APPEAL SUMMARY

Appeal ID: 21923

Project Address: 151 SW 1st Ave

Building/Business Name: PAE Living Building

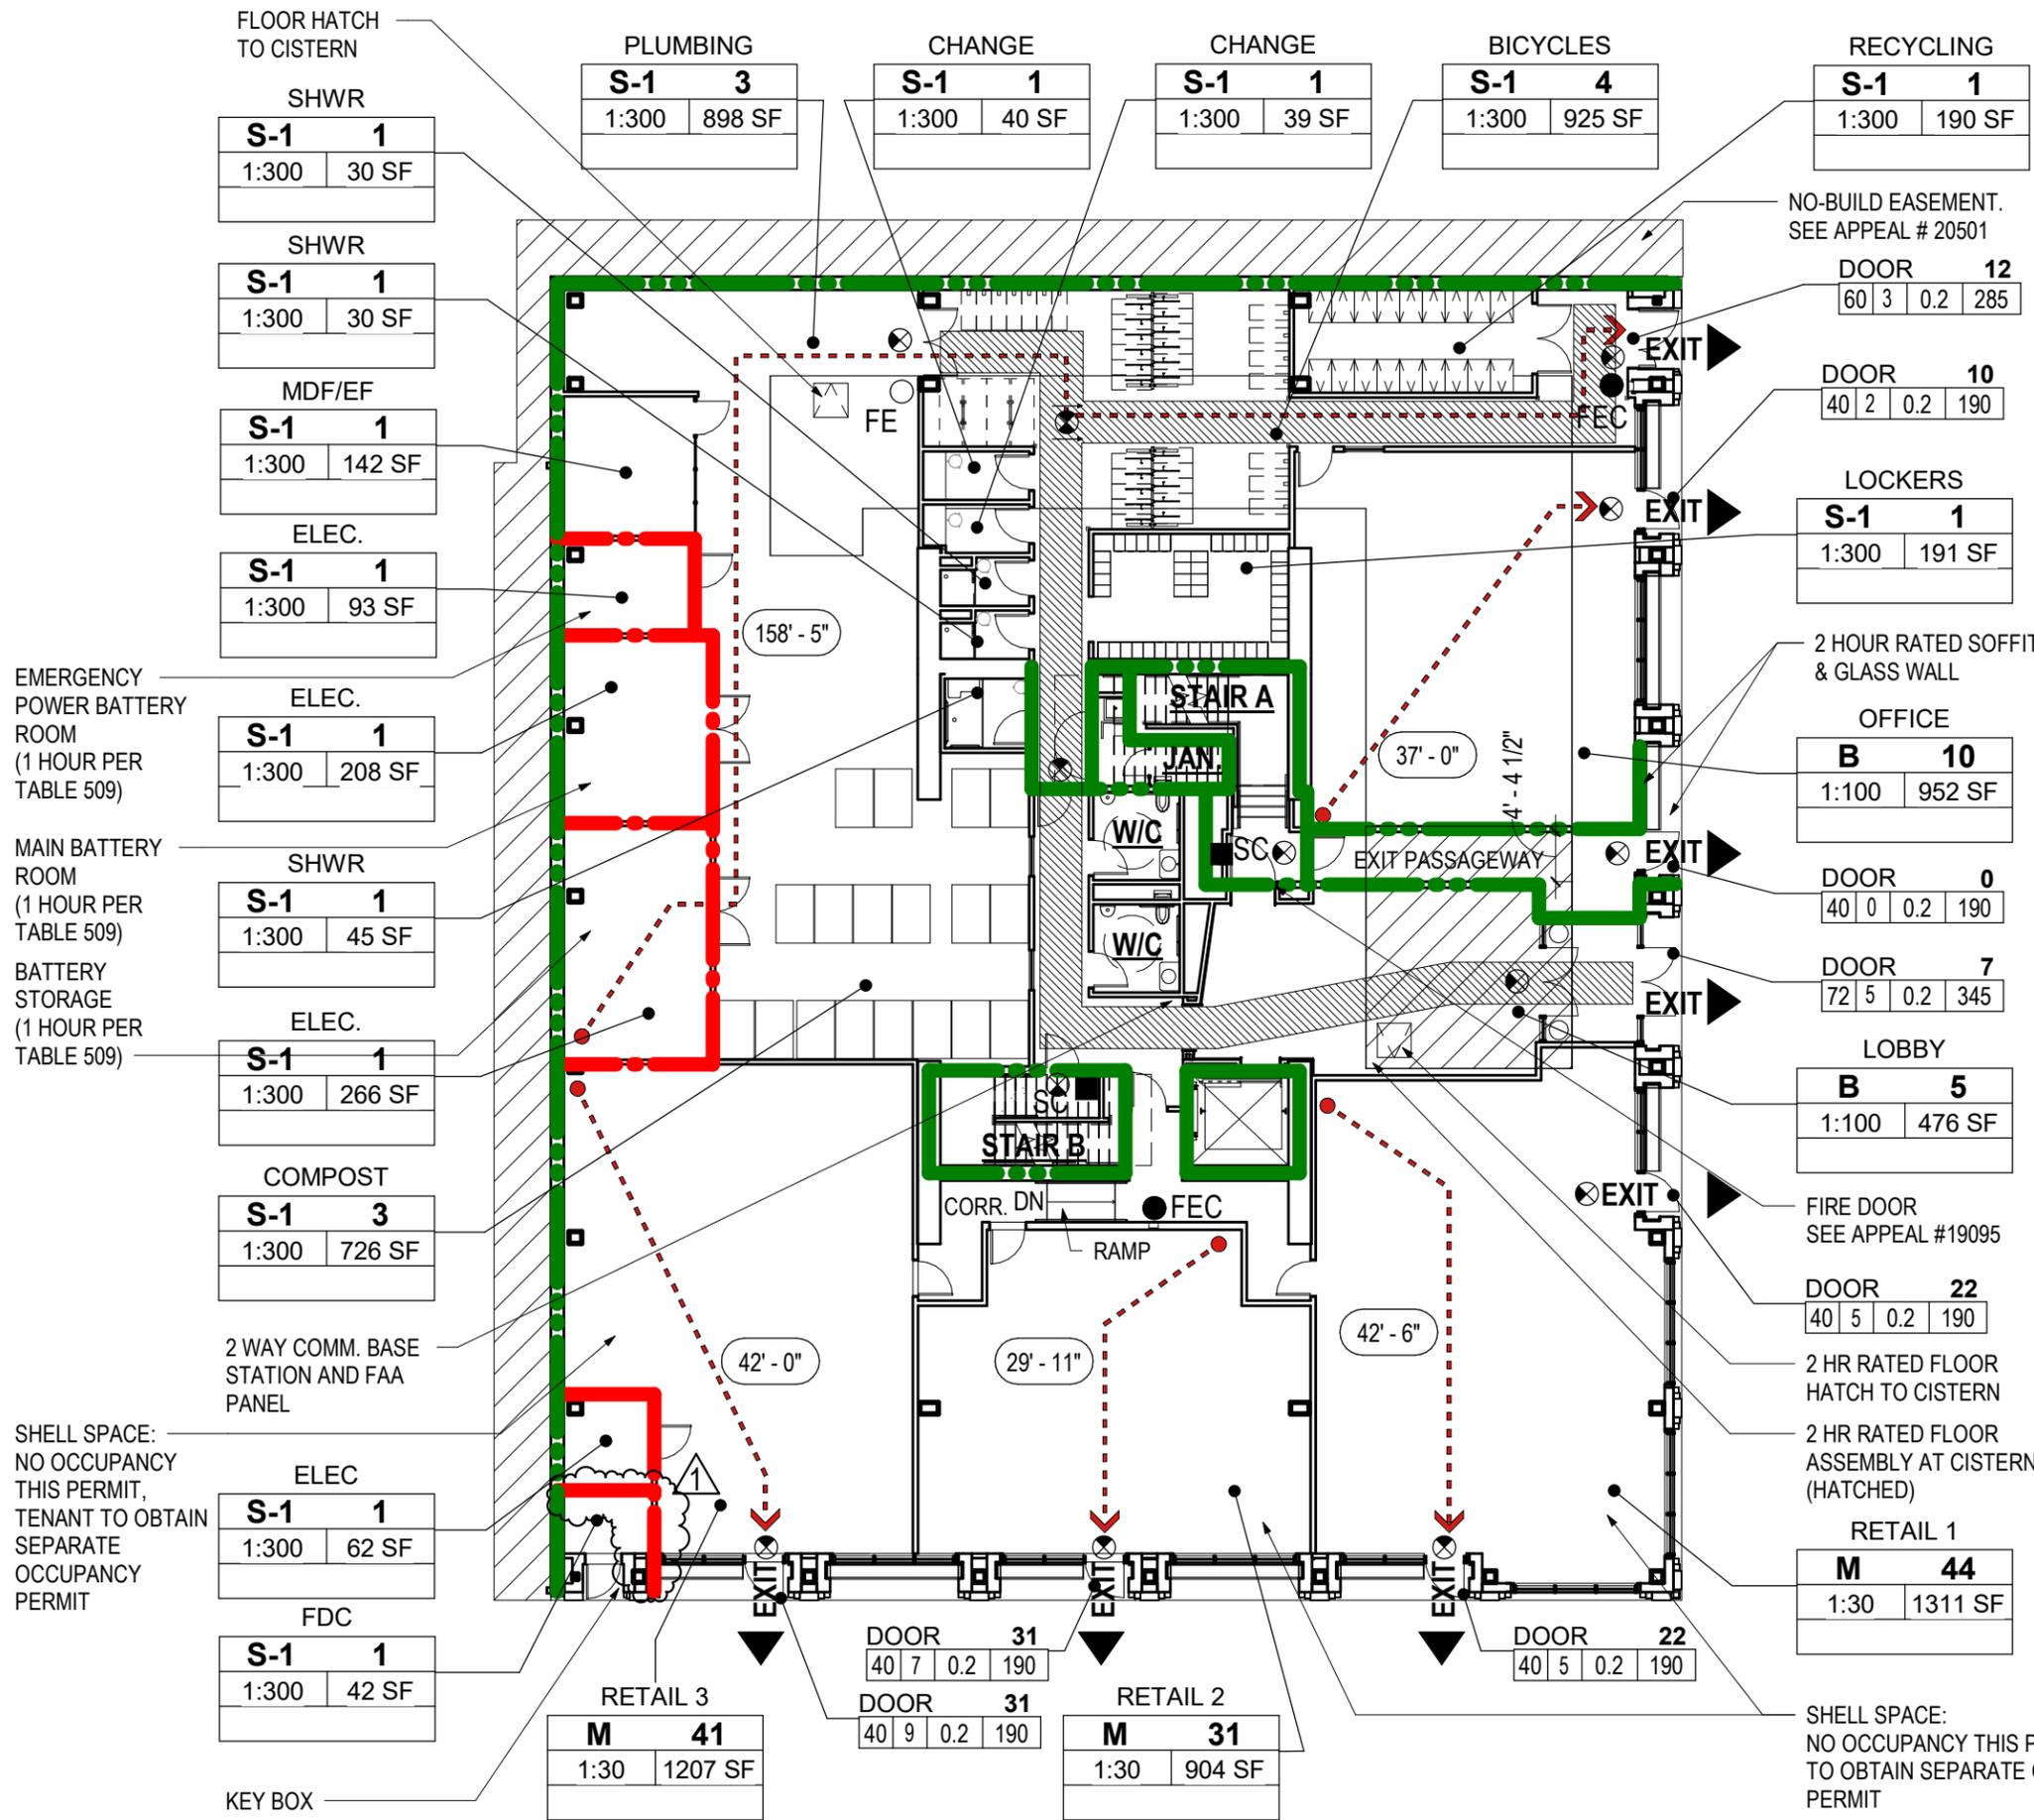
The proposed design follows the same design intent as previously stated with the following exceptions. The door orientation between Stair A and the Lobby is now mirrored so when the door is in its open position it will not block access to the exit passageway. We are providing a 2-hour rated partition and 90-minute rated door with panic hardware to separate the exit passageway from the exit stair per OSSC 1022.3.1.

Reason for alternative The proposed exit stair shaft follows all applicable codes except for the addition of the opening to the lobby. At this opening, we have provided a UL listed (and NFPA 80 compliant), 90 minute rated hollow metal door and frame with a fire rating to meet the requirements of Section 716.5. Once the door is closed, it functions like the 2-hr fire barrier required by section 1022.3.1. The door is released from the magnetic hold open upon activation of the building's smoke detection system, fire alarm system, or power failure. The door does not have lever hardware on the lobby side so it cannot be opened to always maintain the required separation of the exit enclosure.

The proposed design meets the equivalent life safety and fire protection requirements of the code, as indicated above. Additionally, with the revised flipped orientation of the door the exit passageway will always be readily visible and accessible. This will prevent any confusion as to the correct route of exit egress from the building.

Interior exit stair discharge to lobby: Granted as proposed.
